## **Appendix W - MSHA Main West 2006 ARMPS**

## Example of MSHA North Barrier ARMPS Model

Figure 117 - North Barrier MSHA 2006 ARMPS Model

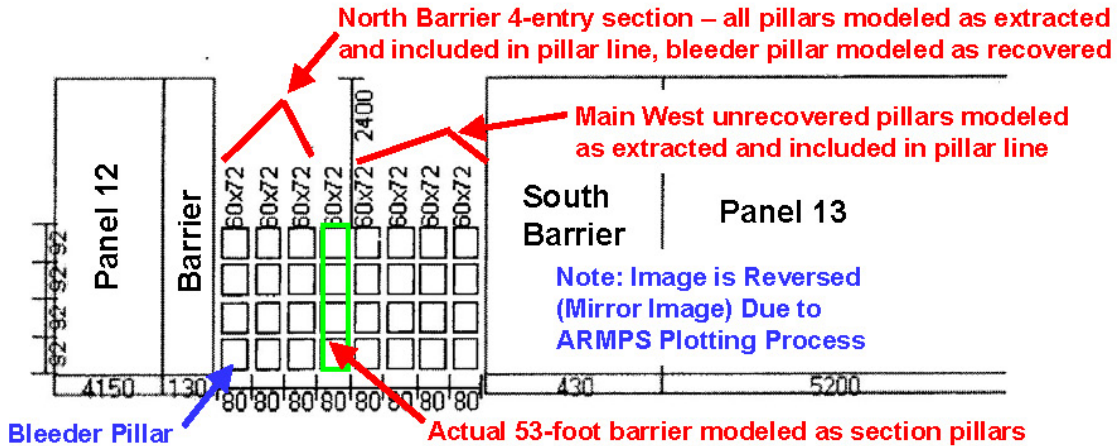
In the North Barrier section analysis, the pillar extraction row included all nine entries as if pillar recovery included extracting pillars from Main West and the barrier separating Main West and the North Barrier section. In the South Barrier section analysis, the pillar extraction row also included all nine entries with the barrier separating Main West and the South Barrier section modeled as an extracted section pillar. This layout generates low pillar stability values in order to model a worse case scenario, considering that only two pillars per row were to be recovered in the North and South Barrier sections, and not eight pillars per row as modeled by MSHA. The MSHA Main West 2006 analysis did not address barrier pillar stability factors.

**ARMPS PStf  
 noted to be under  
 0.42 MSHA  
 derived threshold**

Figure 118 - South Barrier MSHA 2006 ARMPS Model

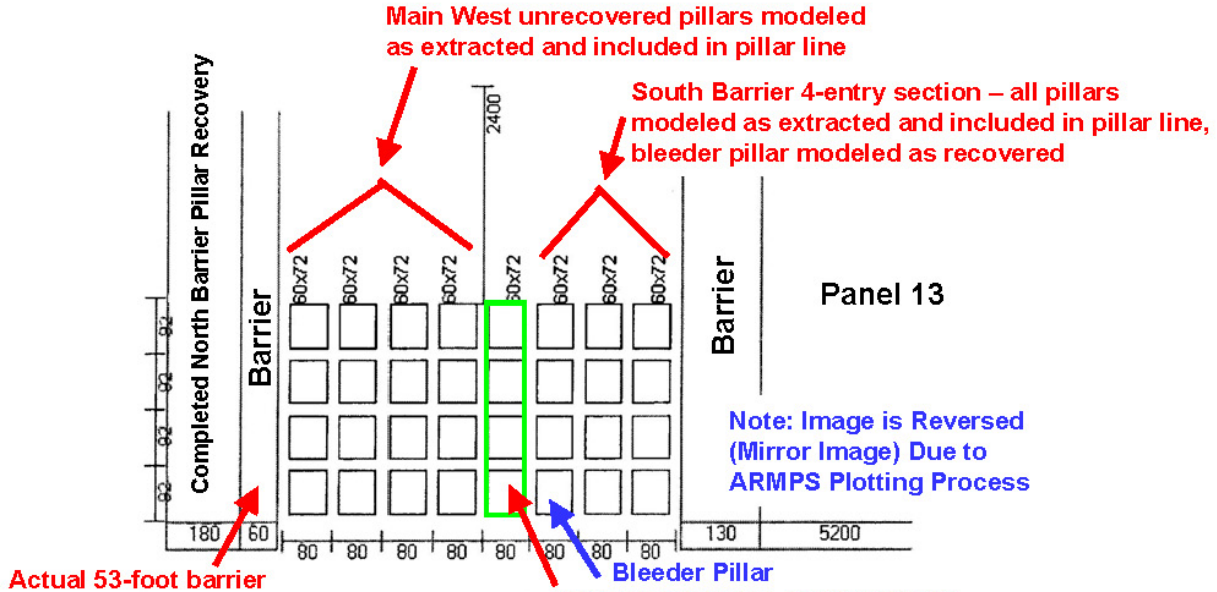
Actual 53-foot barrier

[DEVELOPMENT GEOMETRY PARAMETERS] Barrier modeled as section pillars

**ARMPS PStF  
noted to be under  
0.42 MSHA  
derived threshold**
